PLANNING COMMISSION
Regular Meeting
Monday, June 10, 2019
6:00 PM
Christine Nuernberg Hall

Agenda

SUBJECT: Boulder Venture for Associated Bank and Panera Bread. The applicant is seeking conditional use grant for a restaurant and for modifications to one or more standard district regulations of the B-2 zoning district for a vacant parcel which is non-conforming to the district standards for minimum lot size and building and site plan approval for a 4,500 sq. ft. restaurant (Panera Bread) for the property located at 11249 N. Port Washington Road.

**SITE LANDSCAPE
PLAN**

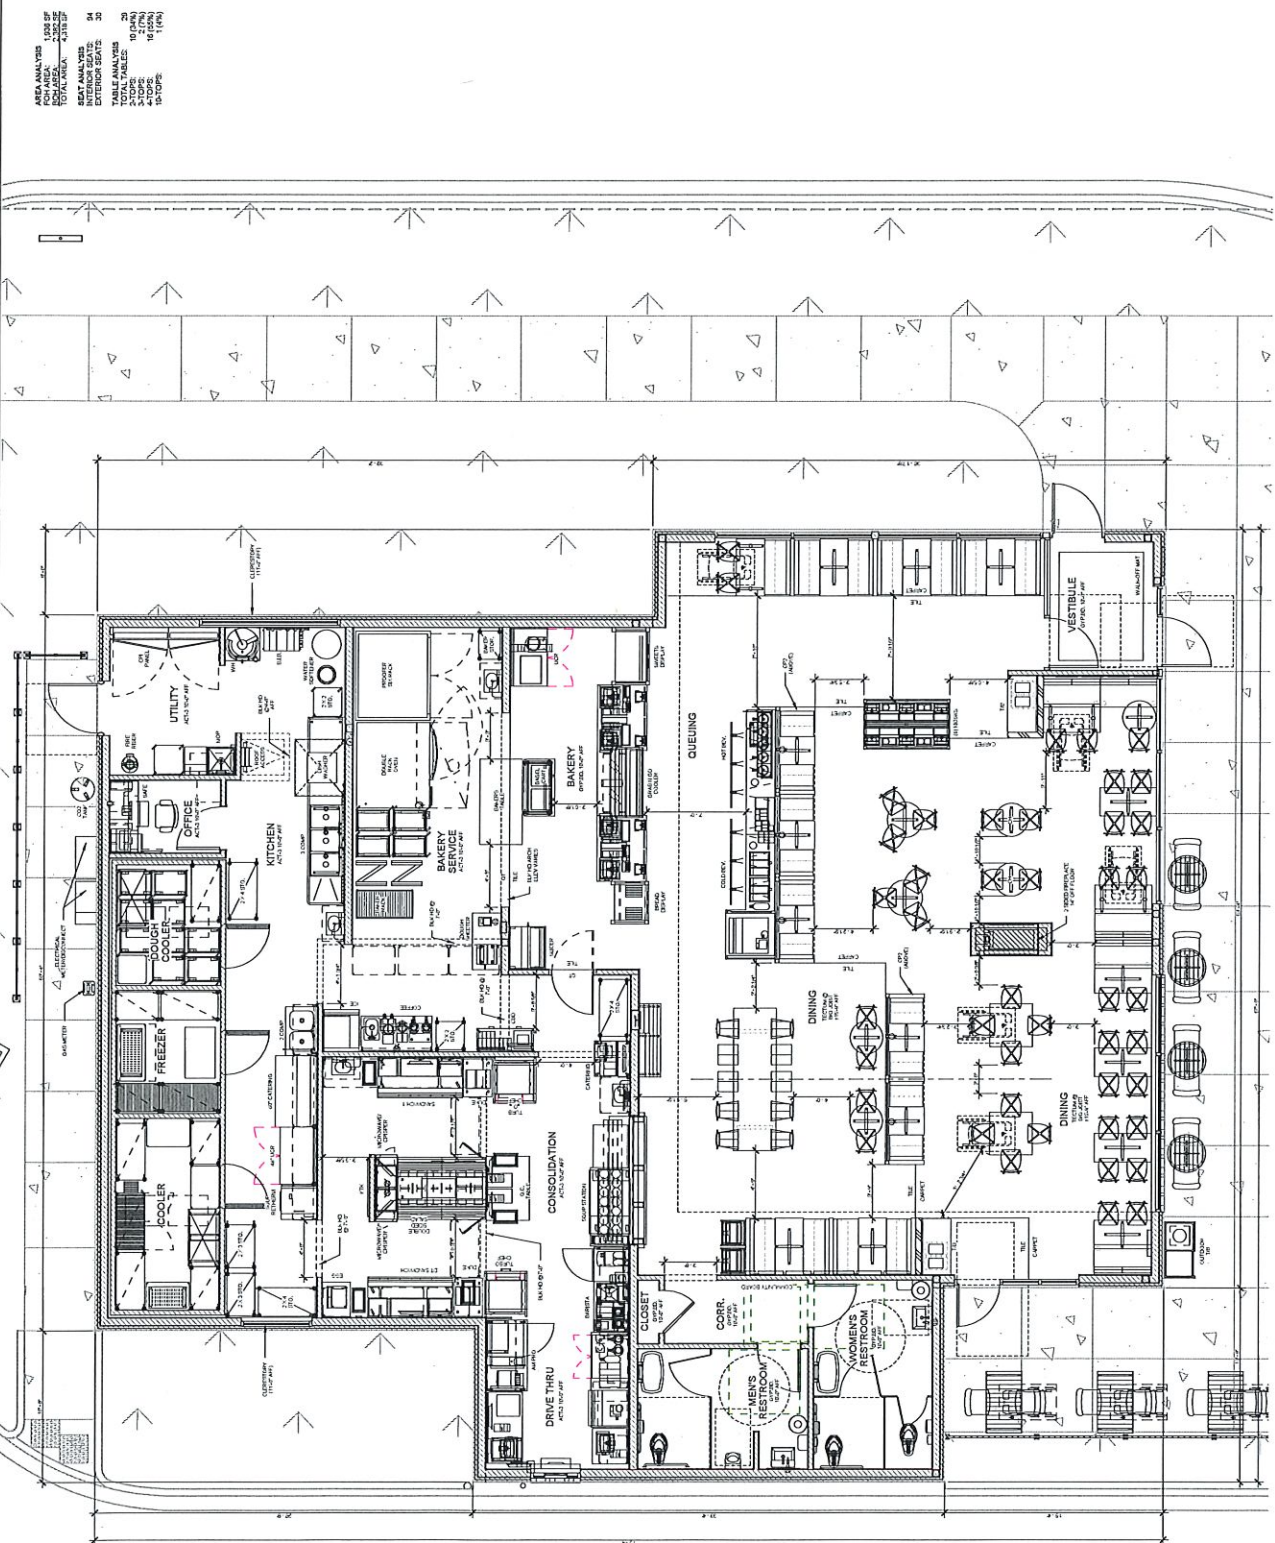
General Overview: Dated 05/13/19 the plan sheet is titled: L101 & L102, Landscape Plans.

- ❖ The plan is NOT sealed or signed by a WIRLA, as required by code. Provide.
- ❖ The overall proposed Landscape sheet is at 20 scale. The plan sheet is clean and the information is discernable.

- The plan provided a complete plant schedules, with: common name, scientific name, size specified and the total quantities, as required. Please see enclosed notes below regarding the proposed plant sizes. Amend Plant Schedule per notes below.

- The plan indicates there are not any ROW (terrace or center islands) Street trees. The plan fails to propose the inclusion of ROW trees. While the plans indicate there are overhead Electric, that has not precluded the planting of street trees in the Terrace in 1000's of cities throughout North America. This proposal fails to provide any ROW Island Plantings. Direction by City Staff/Planning Board.

- In the case of both proposed Amelanchier plants listed in the schedule; the City of Mequon does distinguish between large shrubs and small trees. Unless judiciously used, upright, multi-trunk, large shrubs (small trees) fail to have a long-life expectancy when confronted with repetitive snow loading (plowed P-lots, or when adjacent to a regional collector roadway due to snow plow/snow throw). The best observed example of this, was at Homestead HS, where 4" caliper trees (proposed plot Island plantings) were substituted with 7' multi-trunk tall shrubs. Out of the 100+ small trees/large multi-trunked shrubs planted, zero survived one winter of snow loading. In the case of Homestead HS, the plants failed to provide sustainability in Islands that were 9-12' wide (BOC-BOC). While these graceful plants have a role to play in the landscape, it is my opinion thriving adjacent to a roadway or within a plot

island, is not one of them. Revise the plans, substitute the large shrub/small trees species with medium /large canopy trees. The revised plantings should meet the caliper requirements and will contribute to meeting the 30% shade requirements. The required proposed caliper size is below the standards enforced on other Industrial Drive corridor applications. (see size comments below, Amend plans accordingly.)

- The plan provides minimal planting notes, directions or standards to the landscape contractor. Notes help define the designer's intent, as well as, protect the owner from defective work and, or which contractor(s) have responsibility for what construction areas.

- ❖ The submittal specifies seed TURF, but it fails to provide a seeding plan with: the rate of application of the interim turf/erosion control seeding mix. Plans should be amended, to indicate: 1. Sod/seeding area SYD. Currently seeding is proposed, amend plans to specify: 1.type of seed mix, 2. rate of application, 3. fertilizer type, 4. fertilizer application rates, 5. number of total proposed applications <seed & fertilizer>, Define which contractor is responsible for fine grading and define the performance level of the finished surface prior to seeding. 6. The City of Mequon applies a performance criterion for approving TURF acceptance. 7. The OWNER accepts multiple seeding may be required to meet the performance requirements of turf. 8. Failure to meet the TURF performance criteria is grounds for withholding permit of occupancy, or bonding requirements. 9. Failure to implement seeding without enough time to establish a turf that meets the performance criteria, is the OWNER's responsibility. The City has the right to require the execution of fine grading and turf implementation until the performance standards are met. 10. The OWNER may wish to apply SOD if fine grading is not complete to enable the seed turf establishment.

- ◆ The Proposal is adjacent to the Port Washington Road Corridor; the proposed commercial site use has one ingress/egresses off PWR. PWR is one of Mequon's regional collectors and part of the City of Mequon's designated "Gateway" roadways. Since 2012, the P&Z board has requested additional density landscape treatments and larger scale plantings, especially in terrace treatments and site planting areas adjacent to the PWR ROW.

- ◆ For sites adjacent to the PWRd Gateway Corridor, a minimum 4" caliper precedent has been previously established and enforced, for Deciduous Trees. In addition, since 2012, all proposed deciduous trees have been required to have a minimum of 3.5" caliper @ 16" (throughout the site) above the top of root ball. The City of Mequon will reject any poorly formed, undersized plant "for cause". Most often, nursery trees with a stated "range of caliper" (ex: 3"-3.5") caliper, fails to meet the 3.5" caliper requirement when field measured. It is the contractor's responsibility to measure and

ensure all stock brought on sight meets the City of Mequon stated requirements. Multi stemmed Trees will have an equivalent diam root ball, height and a sum of leaders shall have a greater sum diameter area. Per ansi Z60.1, a 3.5" caliper large shrub w/ multi-trunk shall have a minimum height of 12-18 feet at planting. *Revise plant schedule to reflect the minimum plant sizes.*

- ◆ The species proposed have the ability to perform in the local soils.
- ◆ Again, another proposal that has a large majority of small trees/large shrubs in the Plot Islands. Of the two "Medium Height/Canopy" deciduous tree species this design proposed (seven total), only two "Medium" trees are in Plot planter islands. The majority trees shown inside the islands are small trees, or large multi-trunked shrubs. Of all the 23 proposed deciduous trees, only 30% are a medium height/canopy trees; 91% of the trees in the plot islands are small height/canopy trees. When considering this and considering the lack of required density, it is clear why this proposal does not meet the 30% shade requirement. It is this reviewer's opinion, the total % of small trees should not exceed 35% of total deciduous species.

- ◆ The 3.5-4' wide planter along the East entrance is a line of Upright Yews (conifer). This would provide a nice screen /hedge. Unfortunately, Yews are highly susceptible to winter burn and then do not adapt well to salt throw (like what occurs when sandwiched between a Plot and PWRd). Additionally, this is another plant that does not fare well when confronted with snow loading. Considering this and the previous comments concerning the nine (9) Amelanchier shrub/trees along PWRd, the entrance of this commercial development may not be very visually appealing in a few short years. I would suggest a revision of design.
